PLANNING DIRECTOR'S VARIANCE
1231 "I" STREET, SUITE 200, SACRAMENTO, CA 95814

APPLICATION: Planning Director's Variance to reduce the required minimum front yard setback of 25 feet to 17 feet on 2.63 \pm developed acres in the Multi-Family Residential, (R-2B) zone.

PROPOSAL: The applicant is requesting the necessary entitlements to create a loading zone and handicap parking for existing condominiums.

APPLC. NO. P91-149

EXHIBIT A

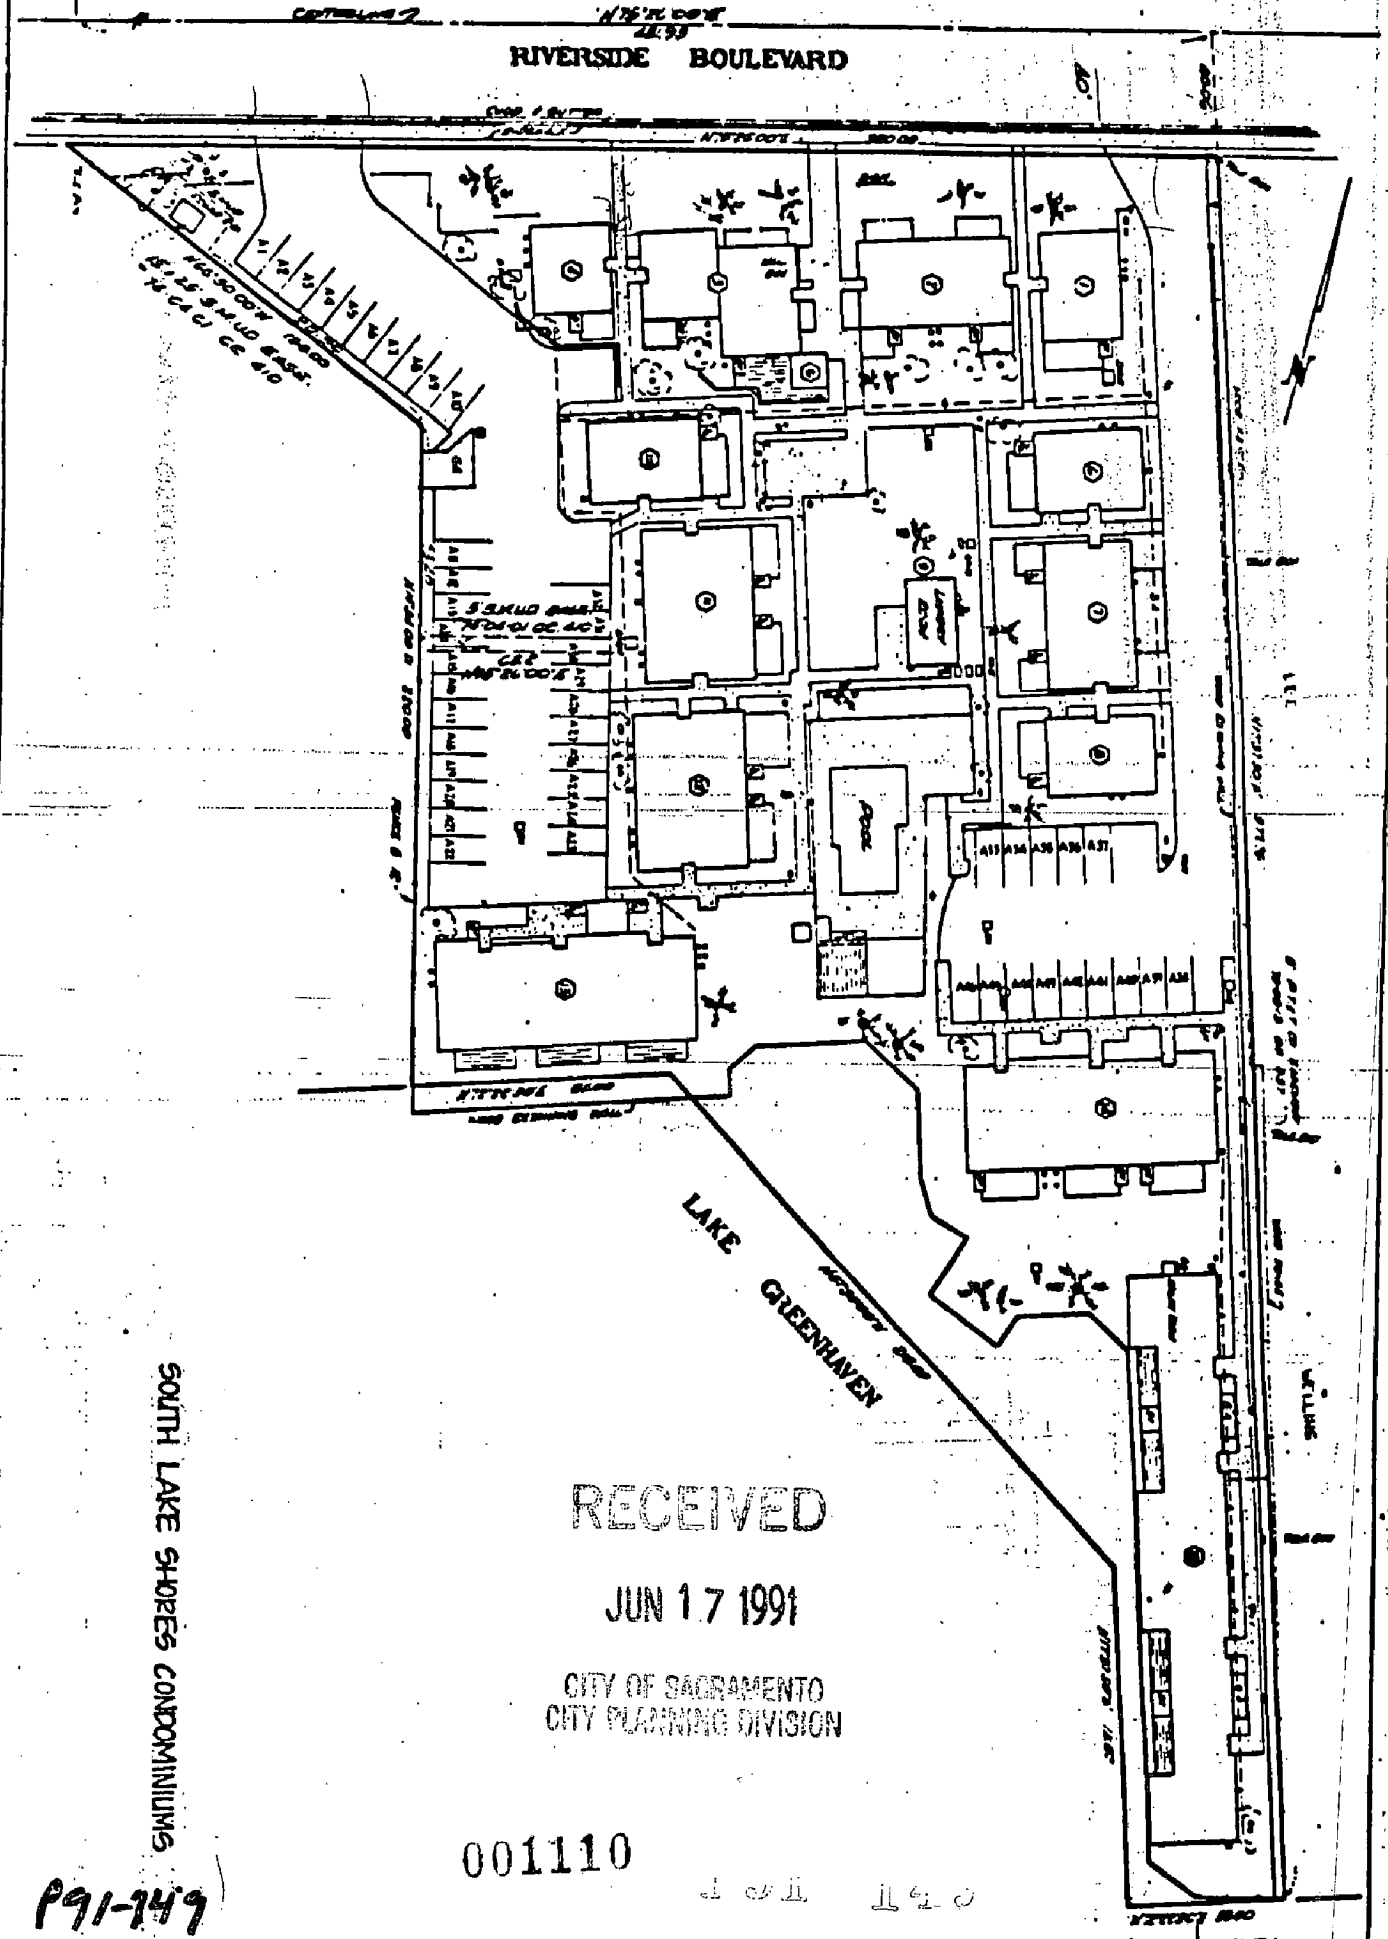
The applicant is proposing to obtain the necessary entitlements to reduce the front yard setback from 25 feet to 17 feet in order to construct a loading zone and handicap parking in front of an existing condominium complex (see Exhibit A).

The north property line of the existing condominium complex is adjacent to Riverside Boulevard. The applicant proposes to relocate the existing sidewalk from its present position southward to a maximum displacement of eight feet from its present location. This will permit a loading zone to be created in front of the condominiums out of the flow of traffic on Riverside Boulevard. The loading zone will be 140 feet long from the start of the angling curb to the end of the angling curb. The center 40 feet will encroach eight feet into the existing front setback area requiring a variance from the Zoning Ordinance. The Zoning Ordinance requires a minimum front yard setback area of 25 feet. Currently, there is limited access to the front center units for delivery purposes. Deliveries or movers must take a very circuitous route to access the front units which is over 700 feet in some cases (see Exhibits A and B). The loading zone would permit direct access to the front units and reduce the carrying distance to under 100 feet for the farthest point. Additionally, the primary entrances/exits for the entire complex will not be blocked by trucks trying to shorten their delivery route. Staff recommends that the loading area be designated as short term parking areas of fifteen minutes.

Staff does not support the use of the area as a designated handicap parking area. Staff does not want to encourage long term parking of any type in this area, but to create an area to facilitate safer loading and unloading for the front units. Designating a specific handicap space in this area would reduce the loading area and impact the entrance/egress route into the loading area.

- a. The variance is acceptable because there are no driveways within the reduced setback area.
- b. The applicant shall reconstruct existing curbs, gutters, and appurtenances to the satisfaction of the Public Works Department.
- c. The owner shall dedicate roadway easements for additional public use to the City of Sacramento.

2. Engineering Development staff comments:
 - a. Parking will only be allowed within the 40 feet area where the curb is parallel to the centerline of Riverside Boulevard. Parking will be prohibited within the 50 feet flair sections in front and back of the 40 feet parking area.
 - b. The Transportation Division does not recommend a handicapped parking zone. Designation of a handicapped parking zone will prohibit the loading and unloading of passengers and goods. A vehicle with a handicapped designation will also be allowed to park with out time limits.
 - c. The Transportation Division recommends parking be designated for a 15 minute time limit green zone. The green zone designation will allow for passenger loading and unloading and the delivery of goods.

1. The applicant shall take the necessary actions with the City Parking Division to provide the short term 15 minute parking spaces along Riverside Boulevard. The parking area shall be designated for a 15 minute time limit green zone.
2. Parking will only be allowed within the 40 feet area where the curb is parallel to the centerline of Riverside Boulevard. Parking will be prohibited within the 50 feet flair sections in front and back of the 40 feet parking area.
3. The applicant shall not designate a handicapped parking zone in proposed area.
4. The applicant shall reconstruct existing curbs, gutters, and appurtenances to the satisfaction of the Public Works Department.
5. The owner shall dedicate roadway easements for additional public use to the City of Sacramento.
